LDS CHURCH PARKING ADDITION

GRADING & EROSION CONTROL DOCUMENTS

GRADING & EROSION CONTROL PLANS FOR:
MONUMENT LDS CHURCH PARKING ADDITION
MONUMENT, COLORADO

PPR2419

**INITIAL GRADING
 & EROSION
 CONTROL PLAN**

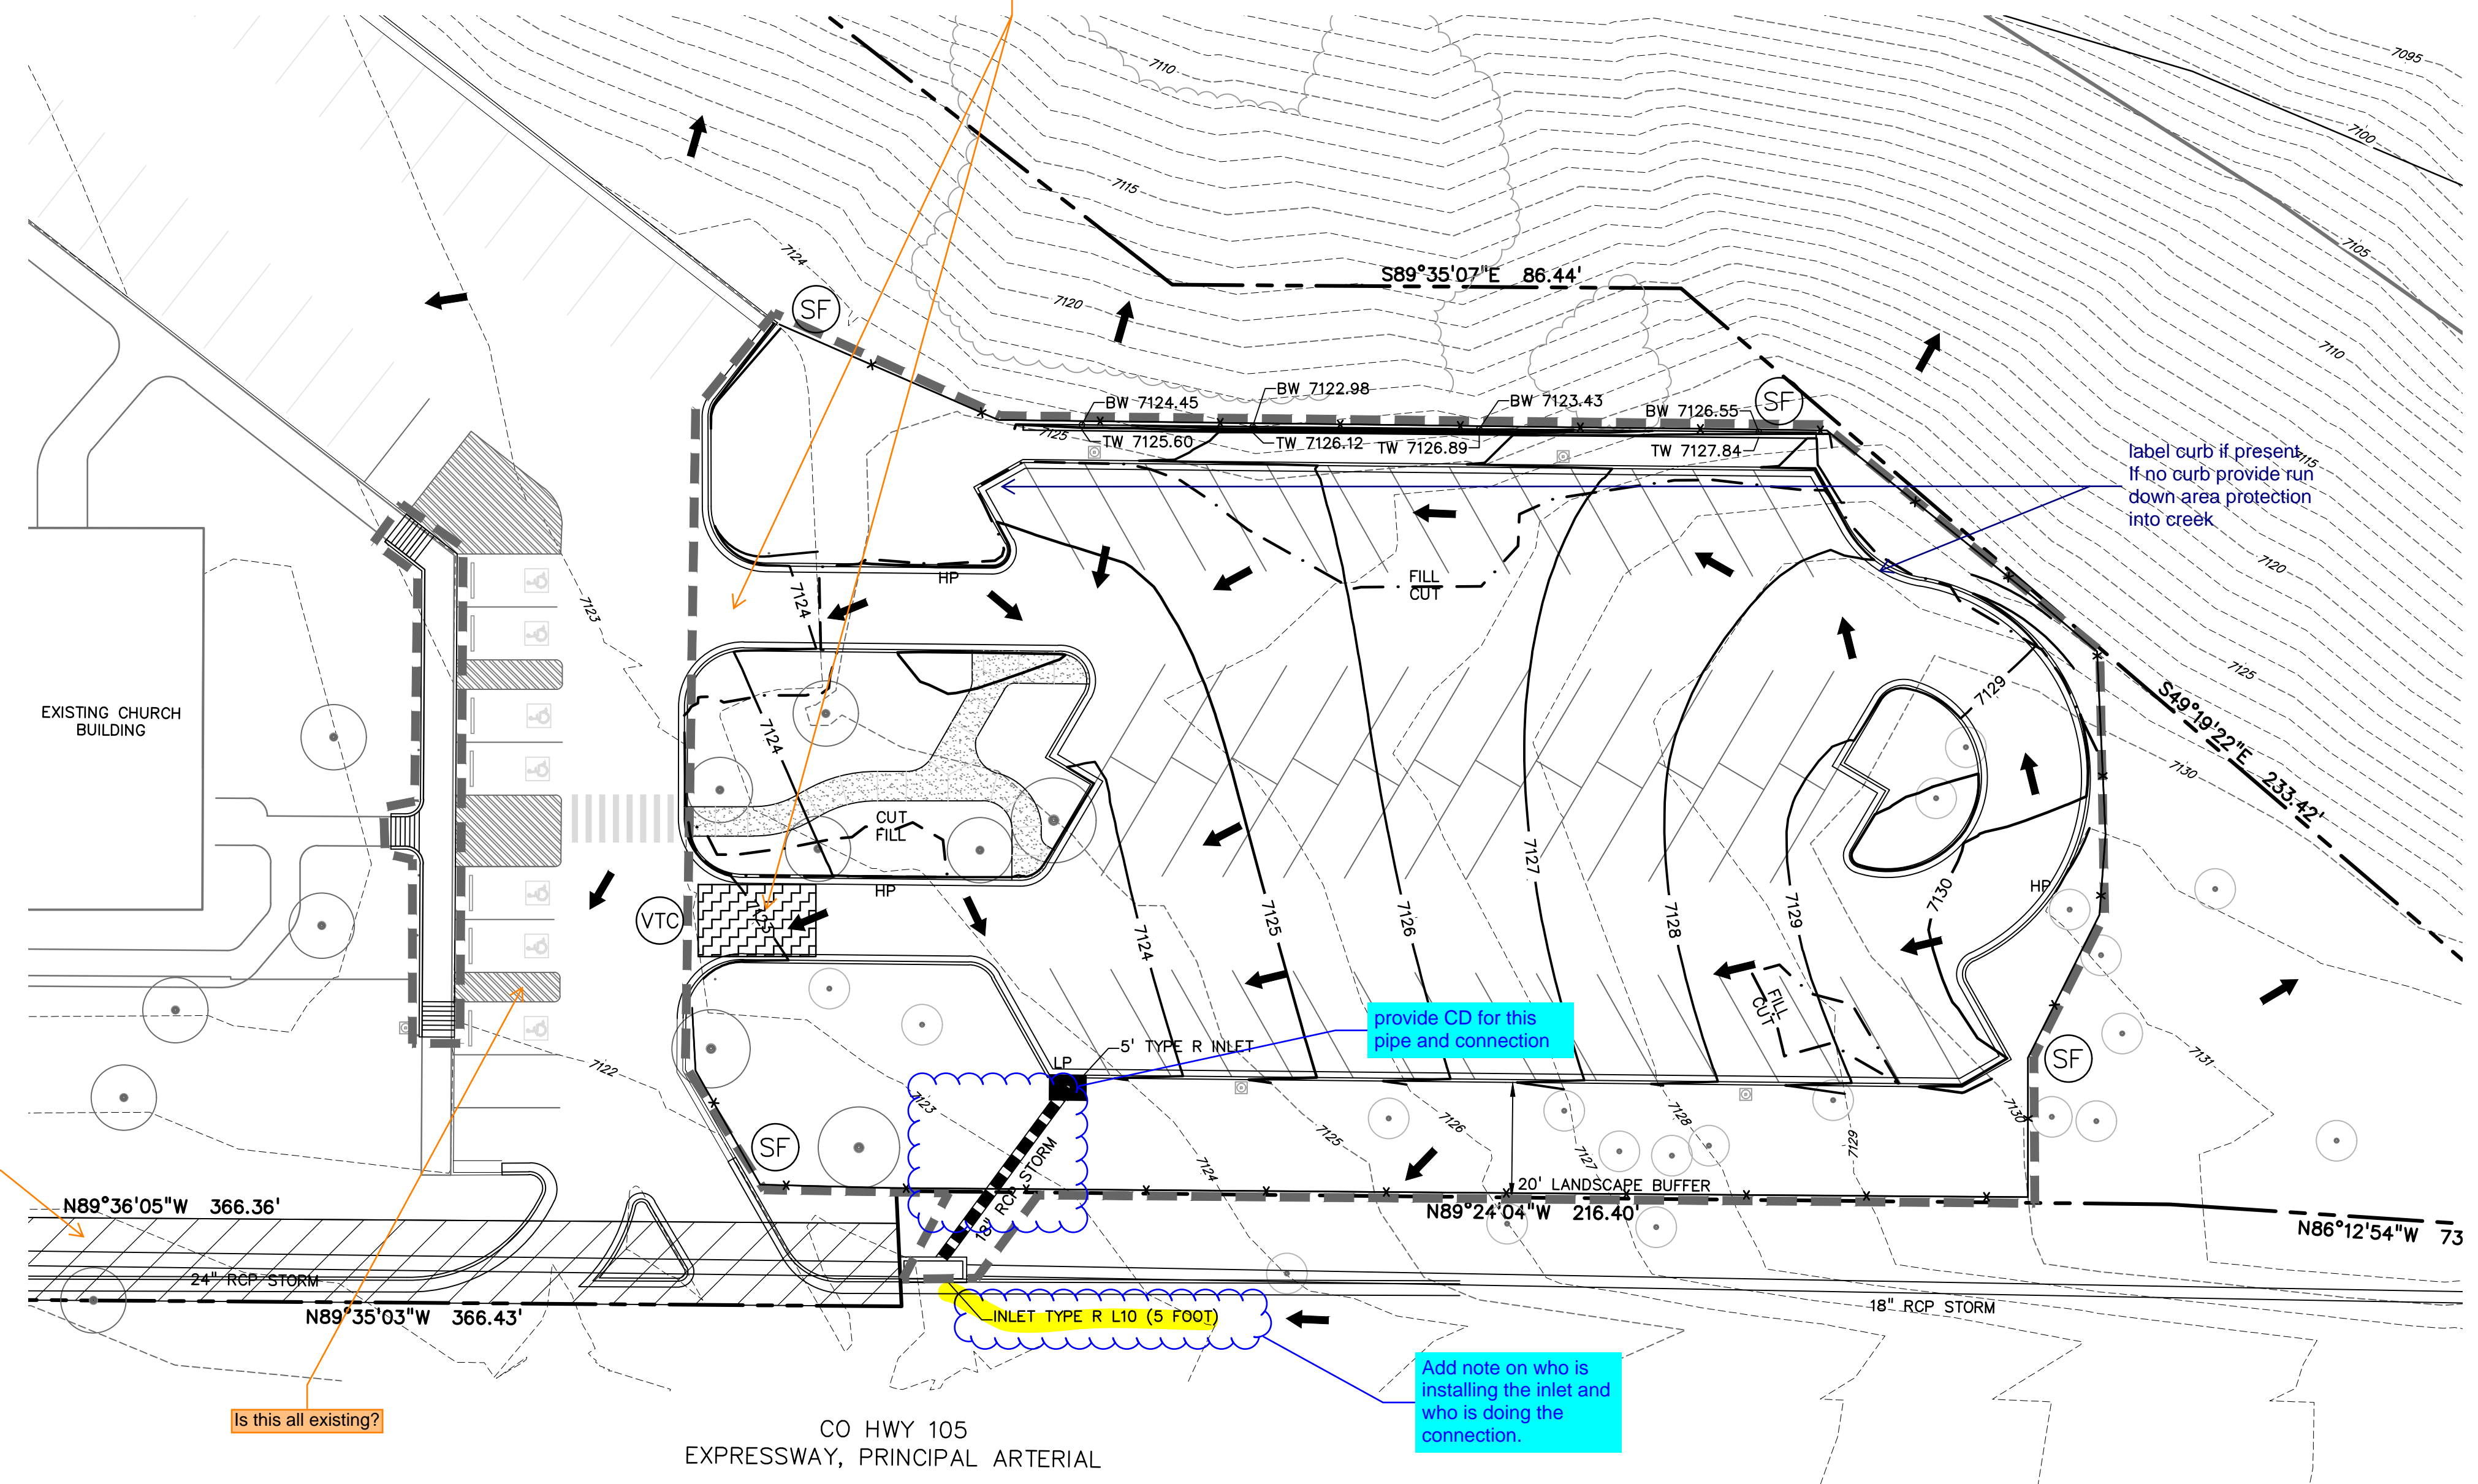
GEC Checklist Item b, e: Show property lines and parcel numbers.
 GEC Checklist Item g: Show all existing utilities

Extend window and show Dirty Woman Creek to satisfy GEC Checklist Item k - existing water course. Show FEMA Floodplain limits as well.

GEC Checklist Item w - Provide VTC at all construction entrances/exits or provide construction fencing, barricades, and/or signage at access points.

label curb if present. If no curb provide run down area protection into creek

provide CD for this pipe and connection

What is this hatching? Clarify in legend. GEC Checklist Item d.

Is this all existing?

Add note on who is installing the inlet and who is doing the connection.

**INTERIM/FINAL
GRADING & EROSION
CONTROL PLAN**

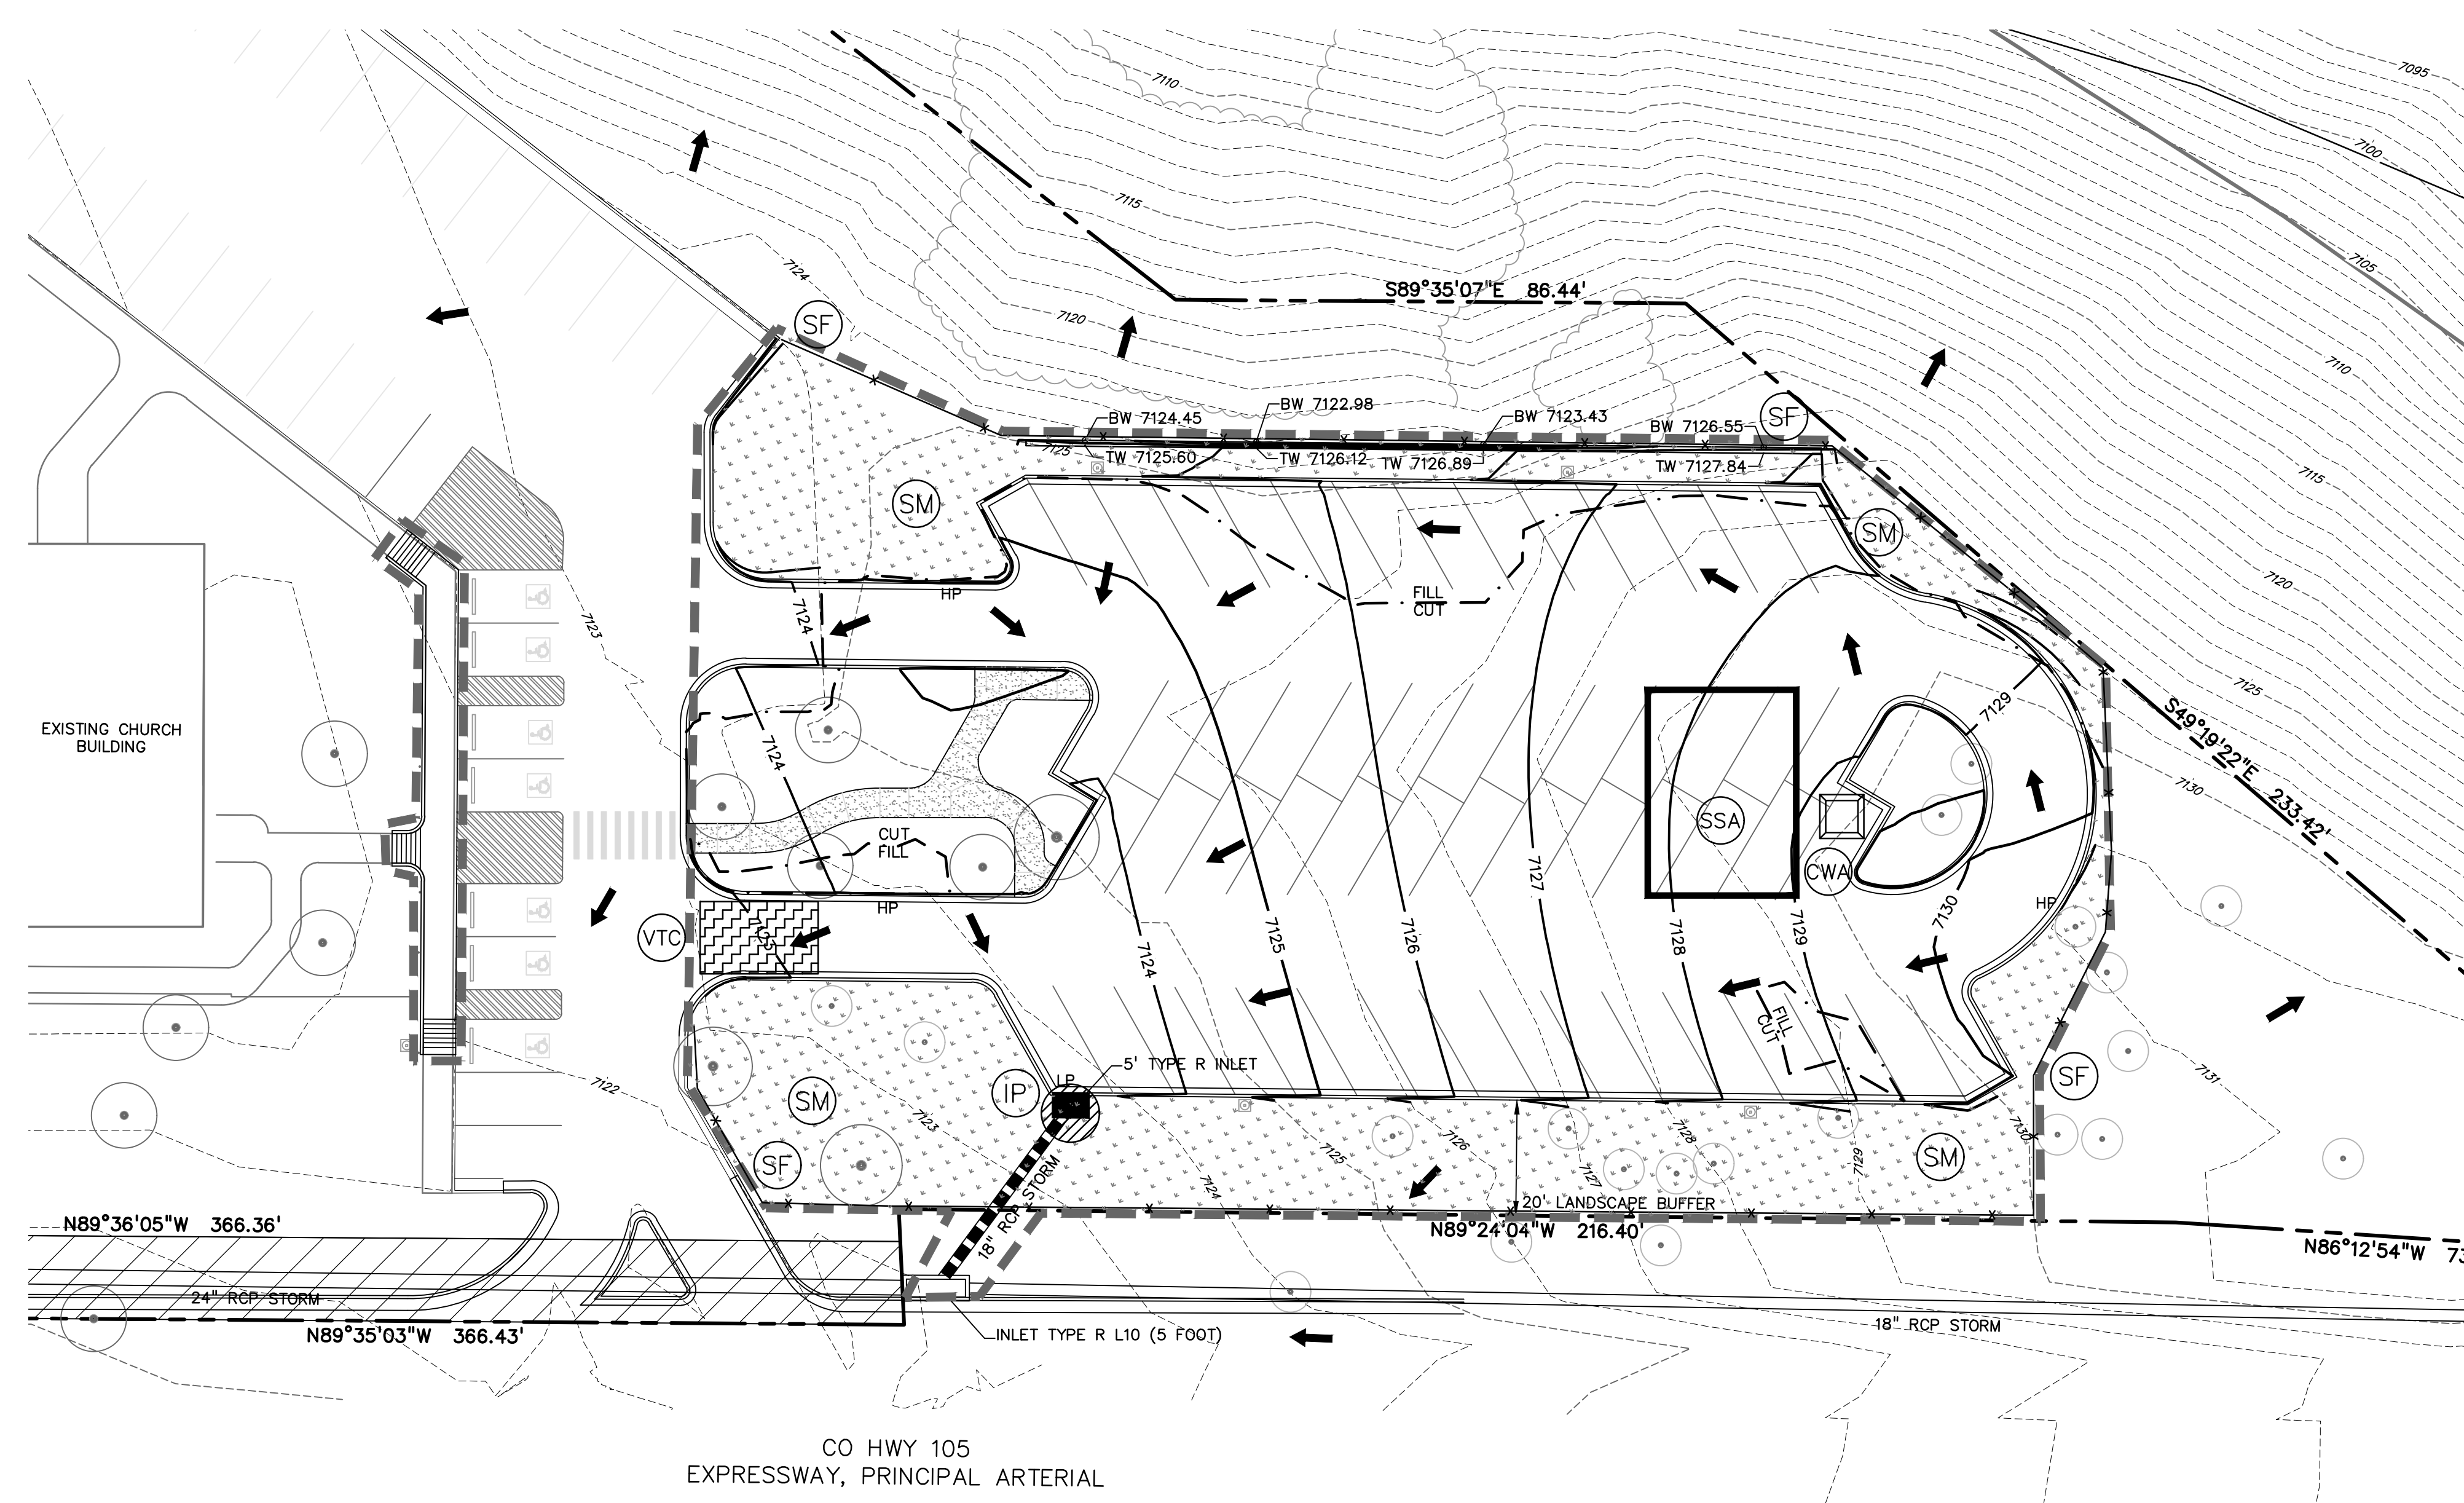
SSA, CWA, and IP should not be final. Change to initial/interim. Final should be items left after construction is finished.
